Groundwater Application Review Summary Form

Application # G- 18466

GW Reviewer DENNIS ORLOWSKI Date Review Completed: 8/01/2017

TO: Water Rights Section Date 08/01/2017
 FROM: Groundwater Section Dennis Orłowski
Reviewer's Name
 SUBJECT: Application G- 18466 Supersedes review of _____
Date of Review(s)

Water-Level Trends in Nearby Wells (static levels only)

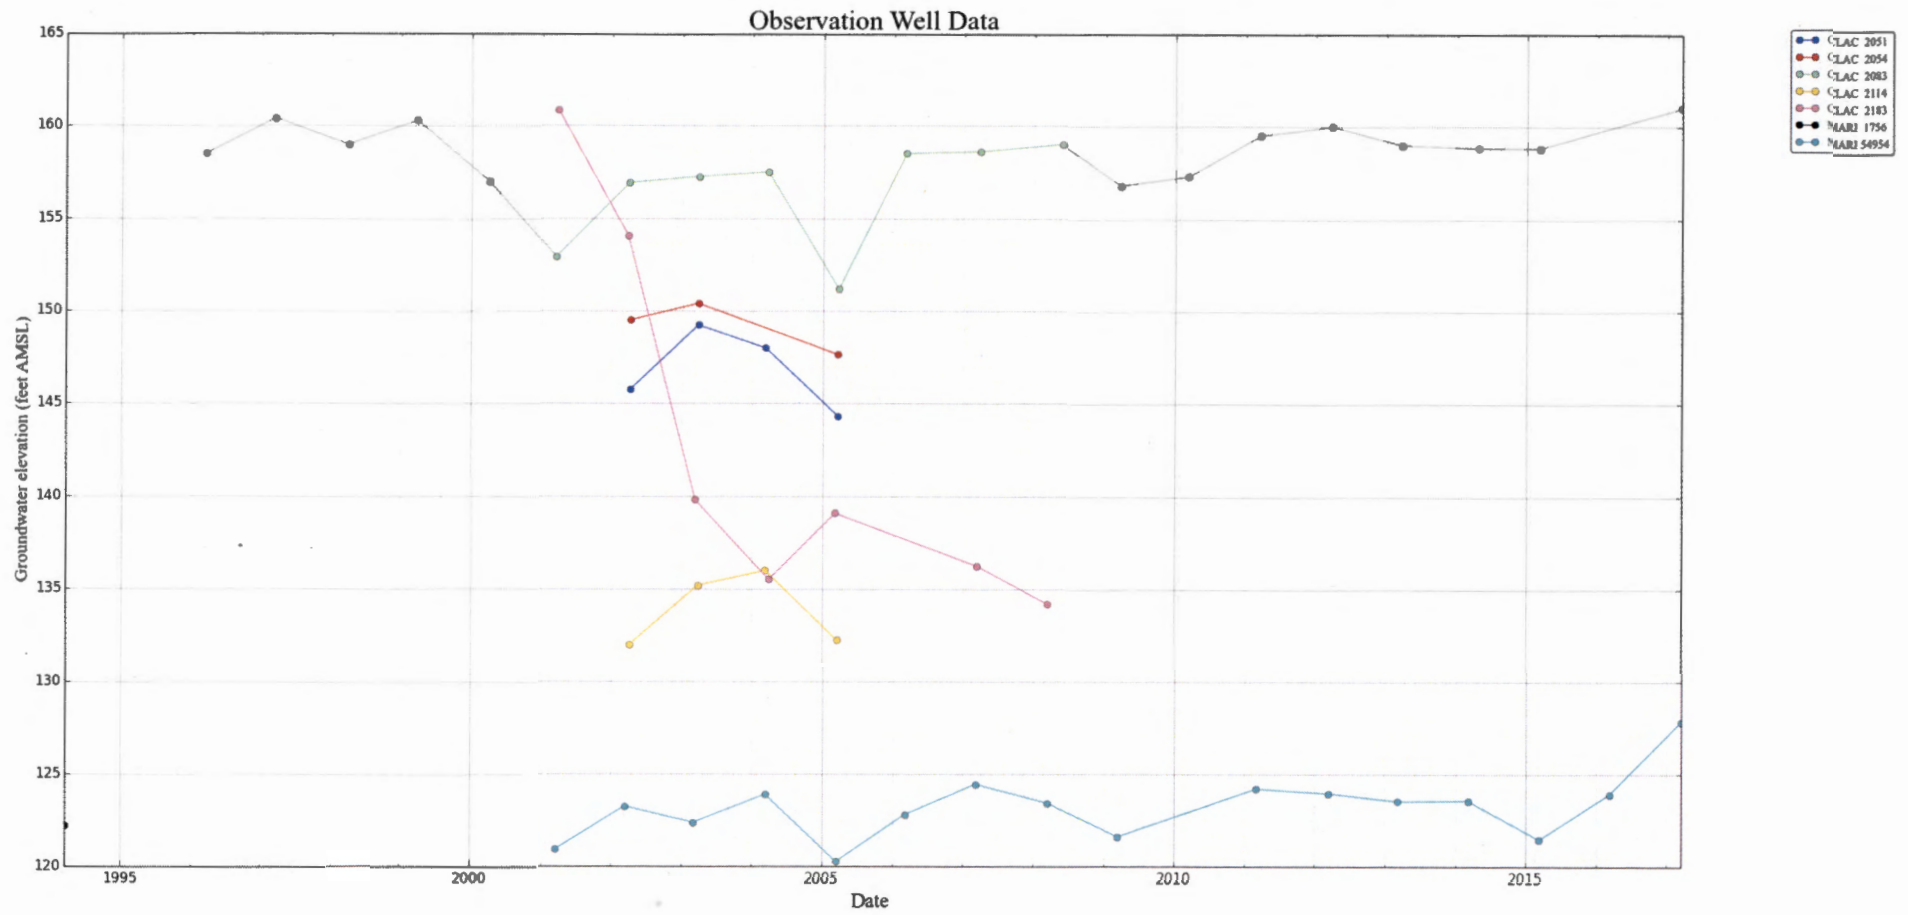
Groundwater levels in some nearby alluvial aquifer exhibited downward trends from about 2001 through 2005, but later data for several of those wells are not available. However, other wells which also exhibited a decline during that period have since exhibited stable or even increasing groundwater levels (see attached hydrograph).

These facts indicate that water for the proposed use is likely available within the capacity of the resource.

Stream depletion model results

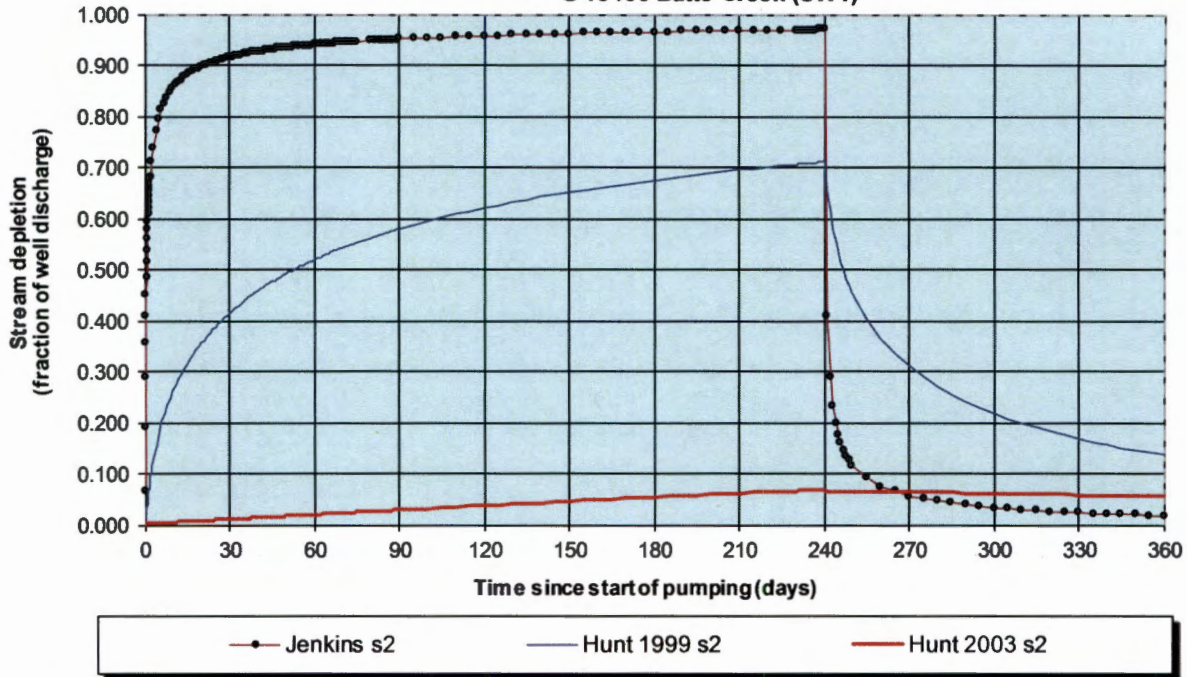
Comments: C3a: The Hunt 1999 and 2003 green depletion models were used to estimate interference of SW1 at 30 days (Hunt 1999, Hunt 2003). Both versions were evaluated because it is likely that both model conditions exist along various portions of SW1. That is, at the proposed POA location there is approximately 60-70 feet of confining Willamette Silt (see CLAC 2135, CLAC 2140), extending down to about elev. 120-130 ft. However, nearby reaches of Butte Creek (SW1) are at about elev. 110-130, and thus there are areas where the 'aquifer' is not present at SW1 (i.e., creek is incised through much or all of the silt, depending on location).

Using estimated aquifer permeability, the Hunt 1999 results indicate >25% depletion at 30 days of pumping, but the Hunt 2003 results estimate much less than 25% depletion. Due to uncertain model applicability, interference at 30 days of pumping cannot be estimated with appropriate certainty.

C6. SW / GW Remarks and Conditions: **C3a: PSI was determined because the requested allocation of 0.20 cfs exceeds 1% of the 80% natural exceedance flow in Butte Creek (0.0978 cfs). Thus, if the requested allocation is reduced to 0.0978 cfs (~44 gpm) or less, then PSI would not be found on this basis.**
